PROJECT: Suite Layout - Unit #307 (Type 'I')

PROJECT: PACIFIC GATE (Lot 9)

DRAWING: Esk-307

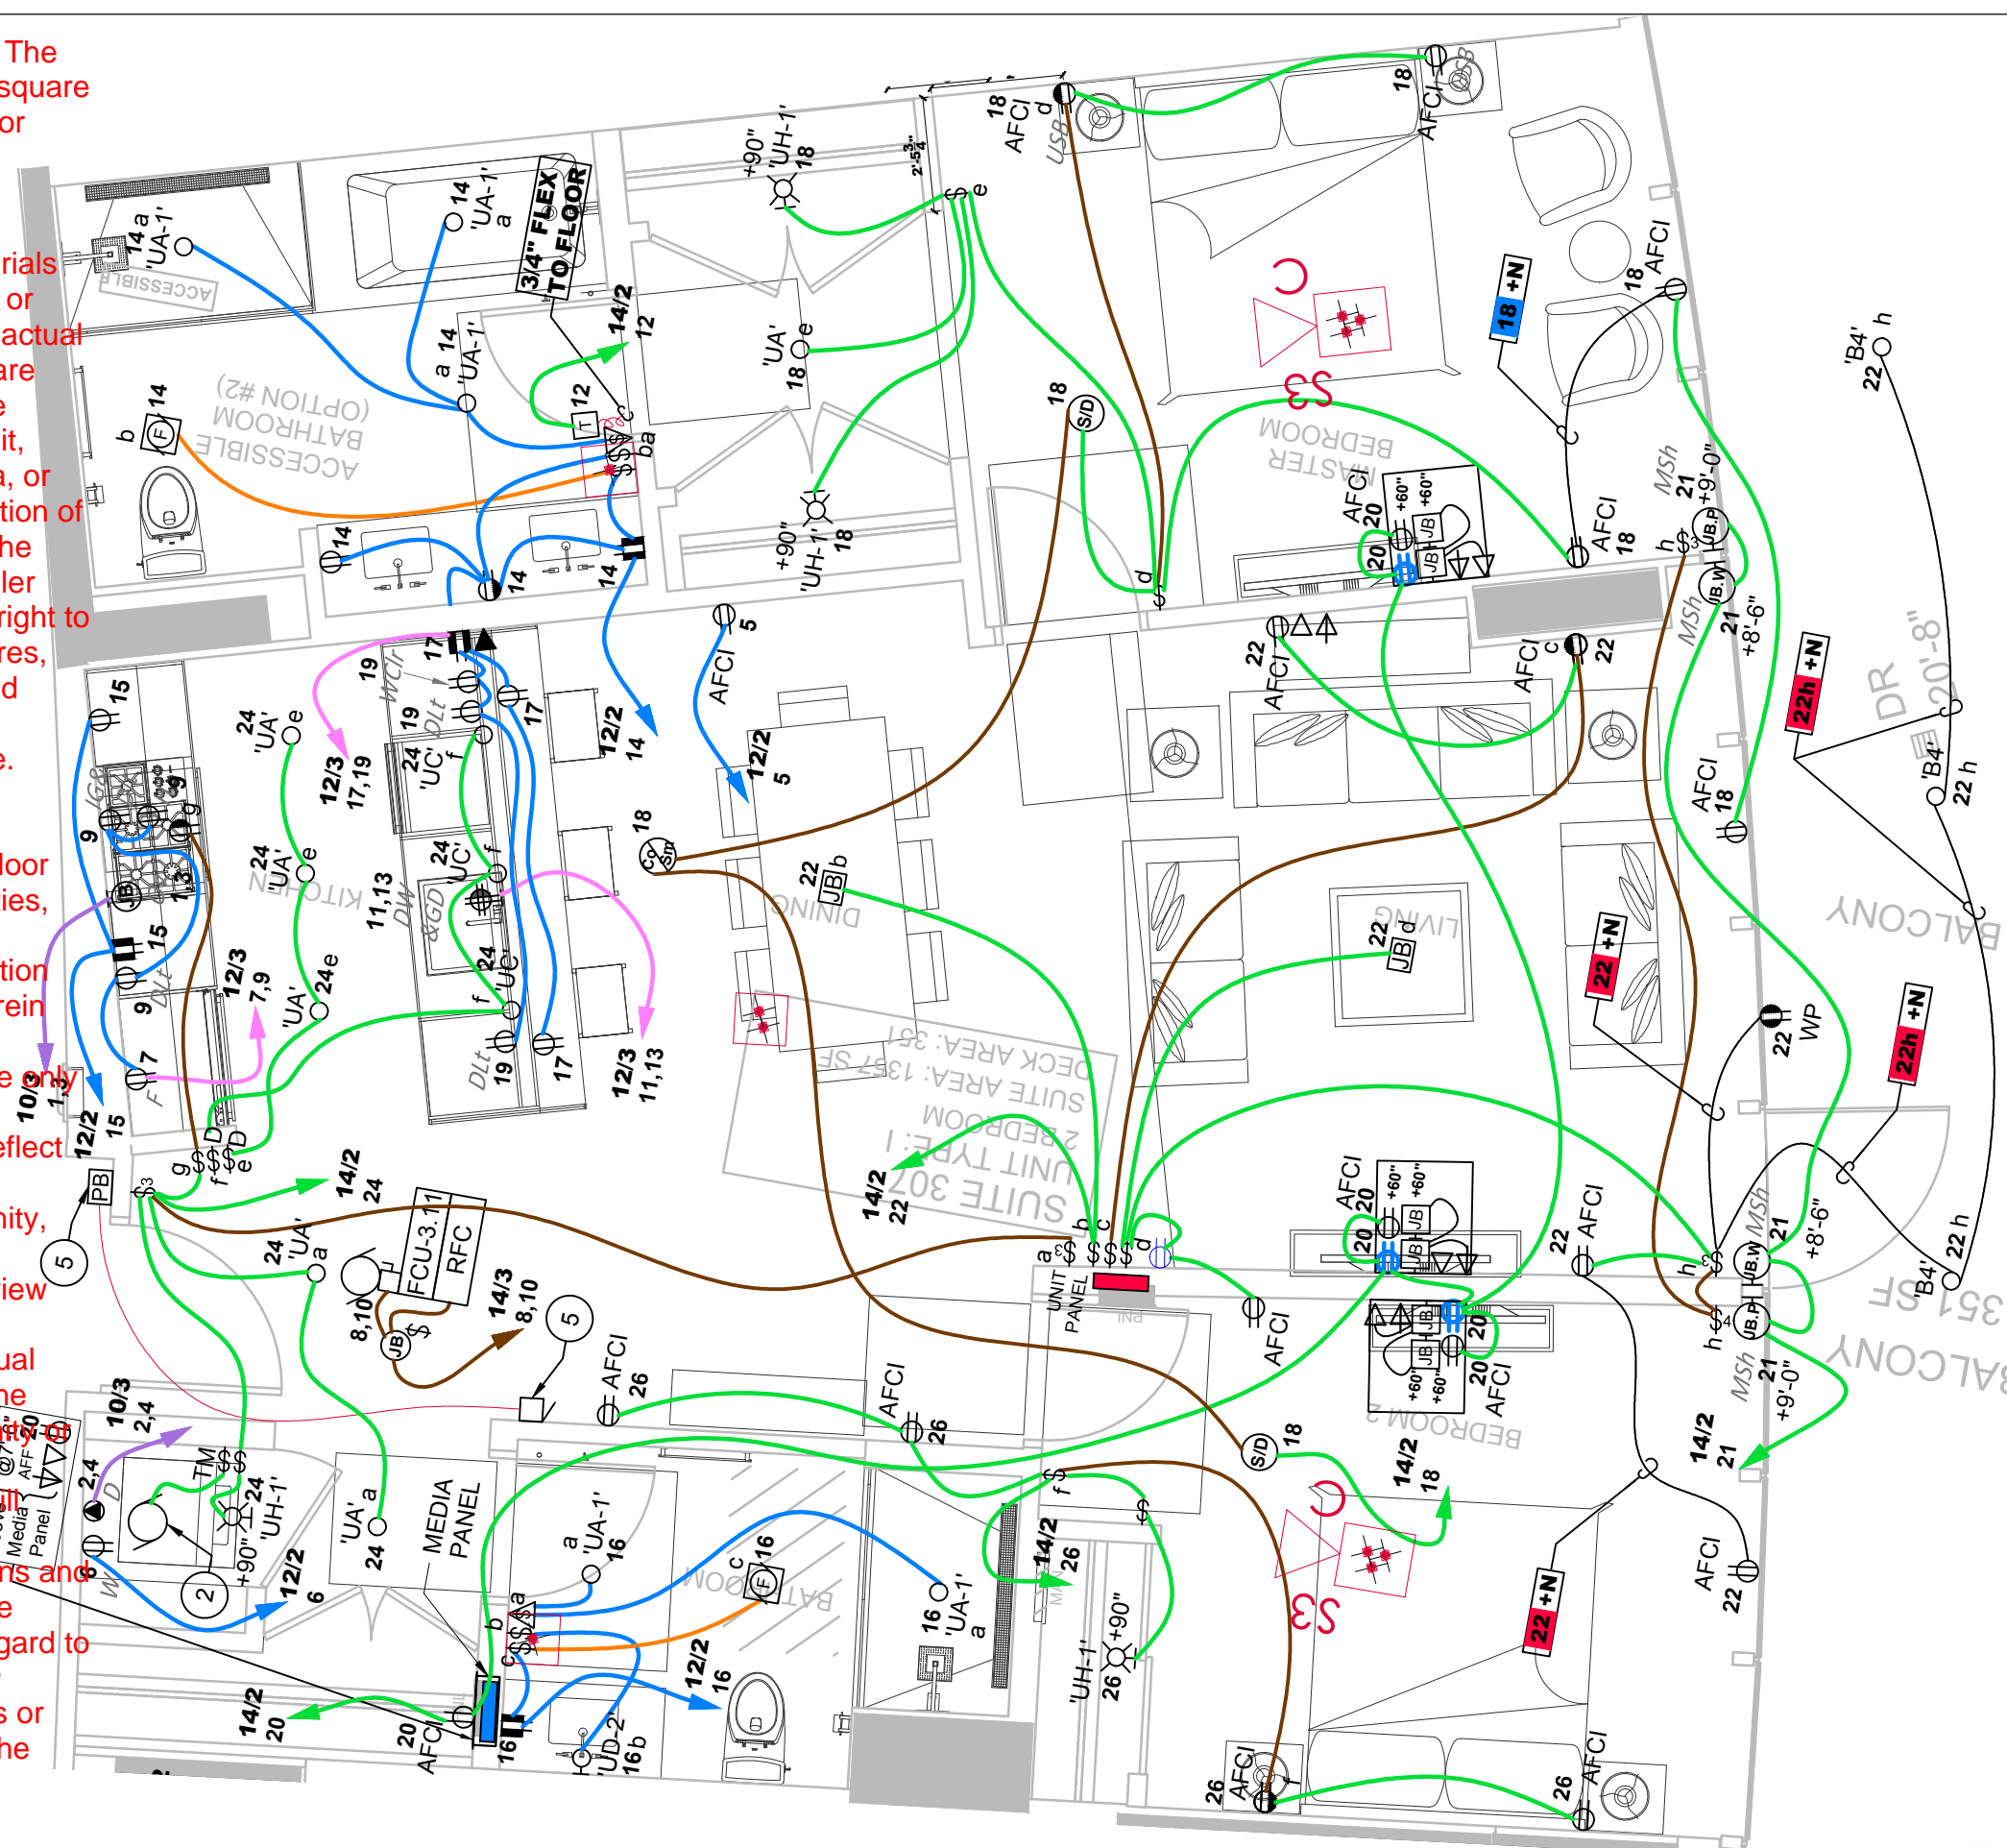
NOTE:
CHANGE ORDER (INCORPORATED):
- WINE COOLER ADDED
